RETREAT AT TIMBERRIDGE FILING NO. 3

CONSTRUCTION DRAWINGS

NOVEMBER 2022

**DOUBLE CONCRETE BOX CULVERT
(2) 12' WIDE X 6' TALL
PLAN VIEW**

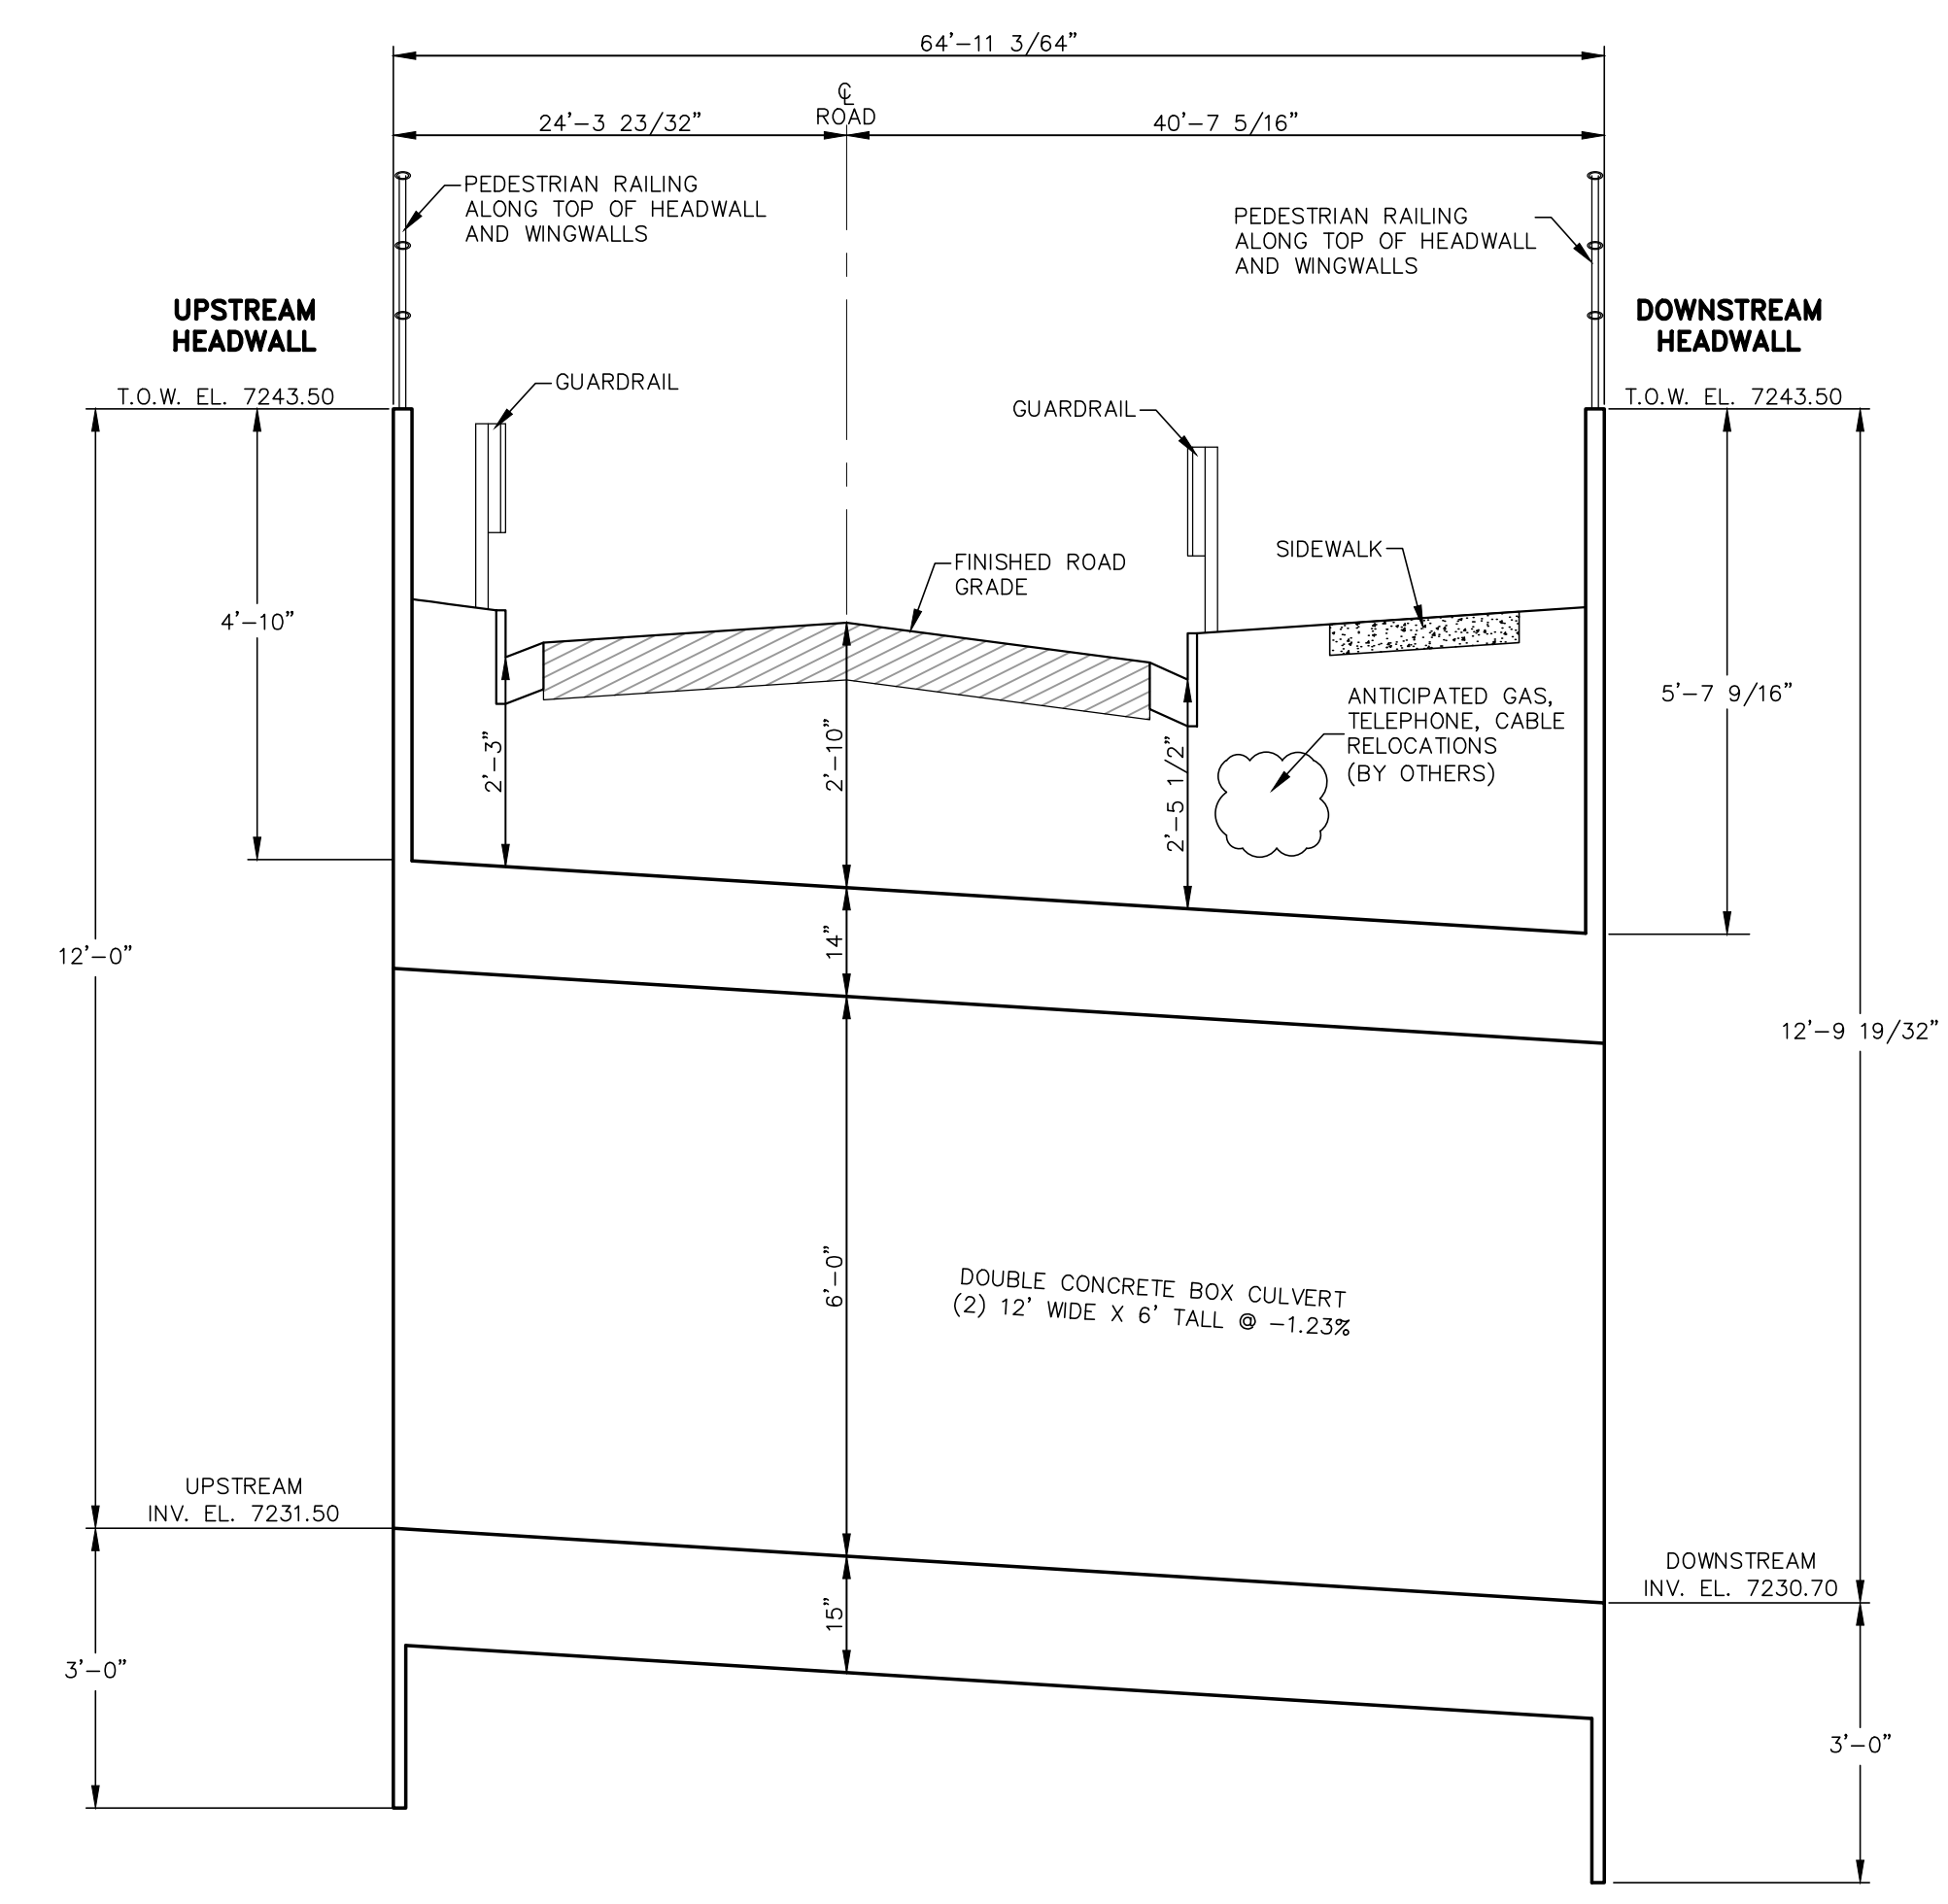
Update sheet reference. Sheet 20 only contains box details.
